RE: Conditional Use – Crook Flat Solar Energy Facility Number 217-20-000320-PLNG

The purpose of this letter is for the Oregon Department of Fish and Wildlife (ODFW) and the Oregon Department of Land Conservation and Development (DLCD) to provide formal comments to the Crook County Planning Commission on Record Number 217-20-000320-PLNG, Crook Flat Solar Energy Facility (Project). The Project is a 156-acre photovoltaic solar power generating facility and associated transmission line designed to operate for up to 40 years.

Figure 1. Map of Crook Flat Project Site and Surrounding County Approved Solar Facilities.

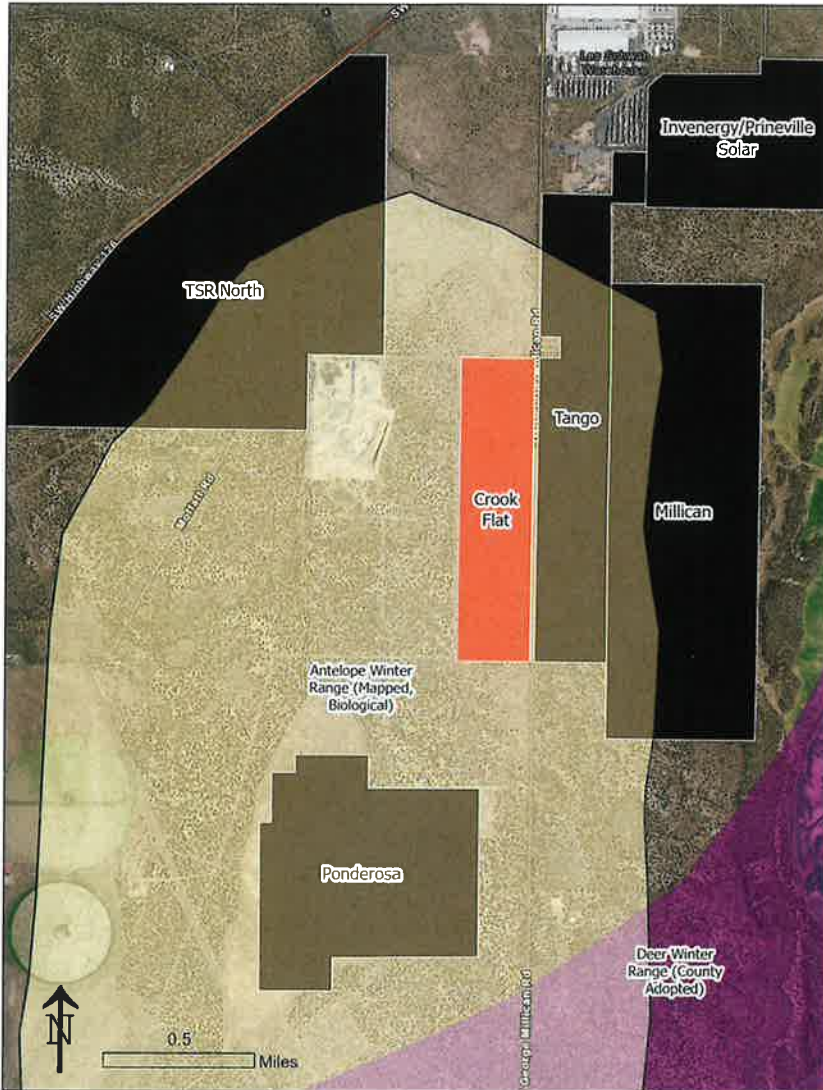
The Project site is located in biological, mapped pronghorn winter range. It is adjacent to two County approved (Tango, Millican) solar facilities and within ½ mile or less of the approved TSR North and Ponderosa solar facilities all within pronghorn winter range (Figure 1). Comprised of a juniper-sagebrush shrubland mosaic with some disturbance, it serves an essential and important function for wintering pronghorn. In addition, the site provides a valuable connection between patches of higher-quality habitat for pronghorn on Powell Butte. Pronghorn are known to have used the site in recent years as evidenced by recent observations.
